61 MILPERRA ROAD, REVESBY, NSW 2212

Landscape Documentation for S4.55 Modification Application

Key Considerations

Drawing Title:
Landscape GF Detail Plan - Sheet 2
 DWG No: **SSD-04**

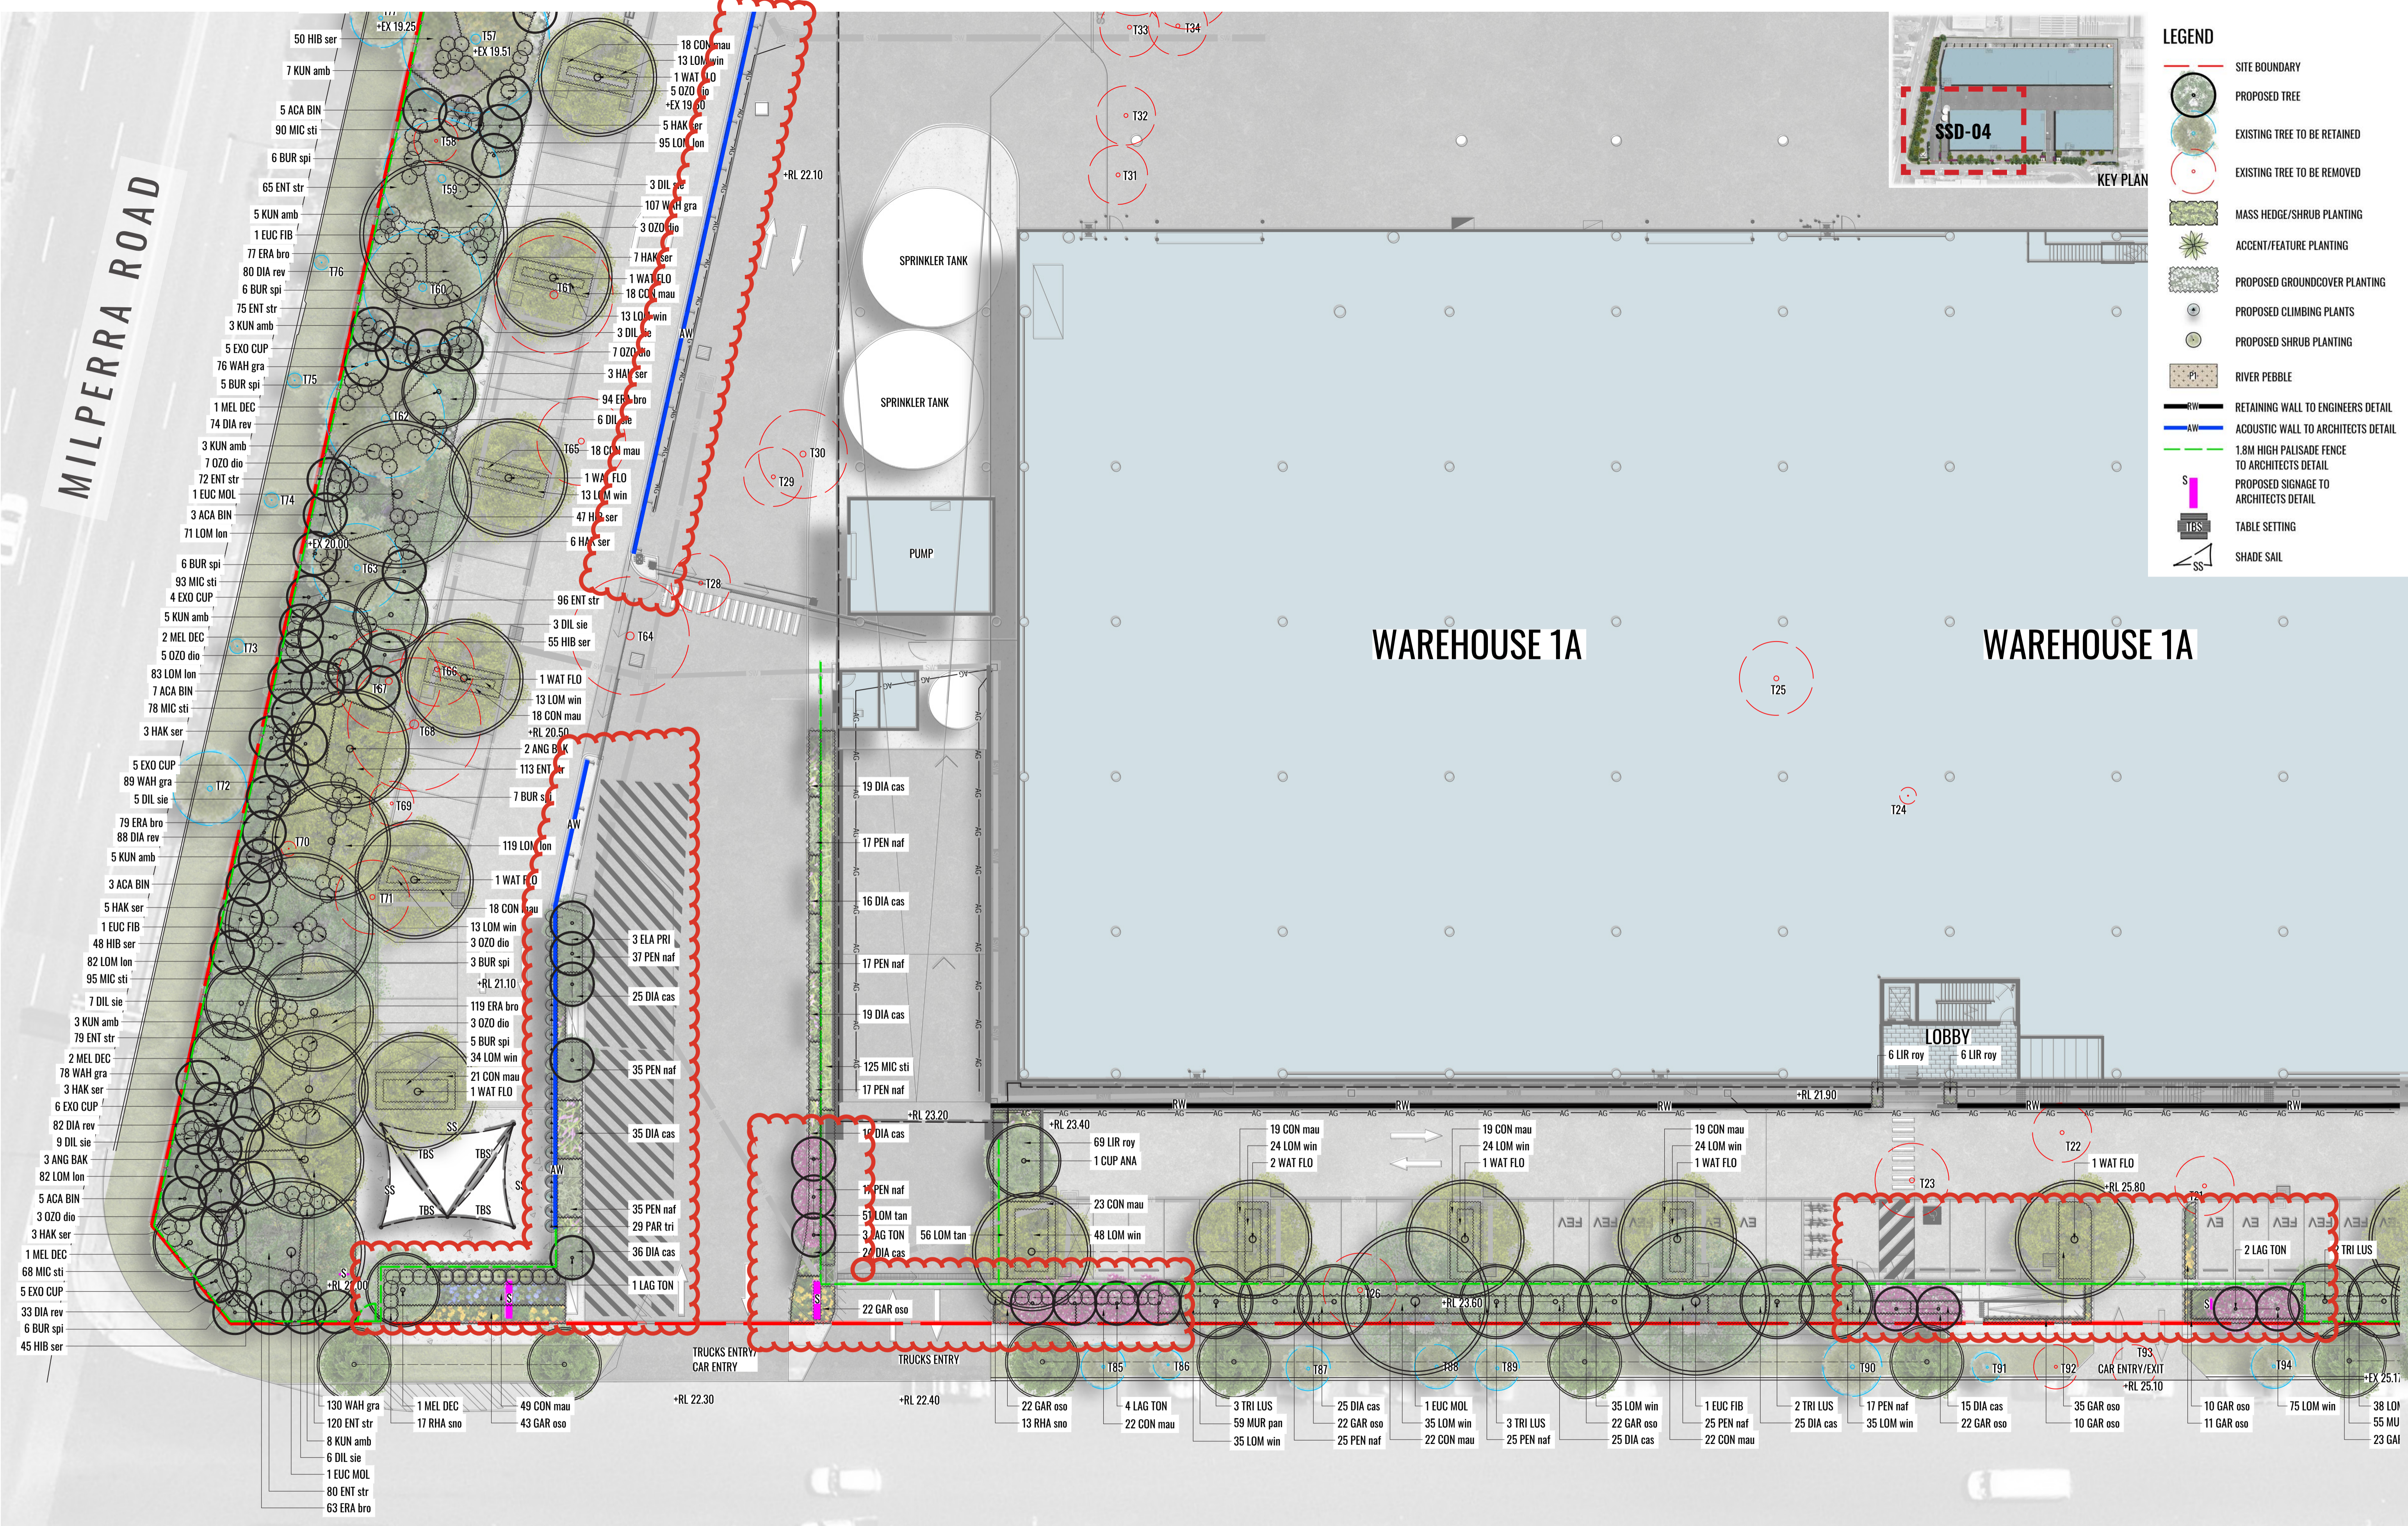
3. Council Requests that the proposal should prioritise the retention and protection of large canopy trees along Milperra Road facing the R2 Zone and existing trees along the eastern property boundary on Mons Street.	Existing trees have been retained where possible along the Mons Street frontage. Please refer to SSD-03 and SSD-04.
Landscaping

15. In accordance with the CBDGP 2023, Council requests that the proposal incorporates a minimum 10m wide landscaped area along Mons Street to enhance the streetscape and provide green space.	A 3m wide landscape setback has been provided to match the existing neighbouring sites and includes large canopy trees to soften the building facade. Please refer to SSD-04 and SSD-05.
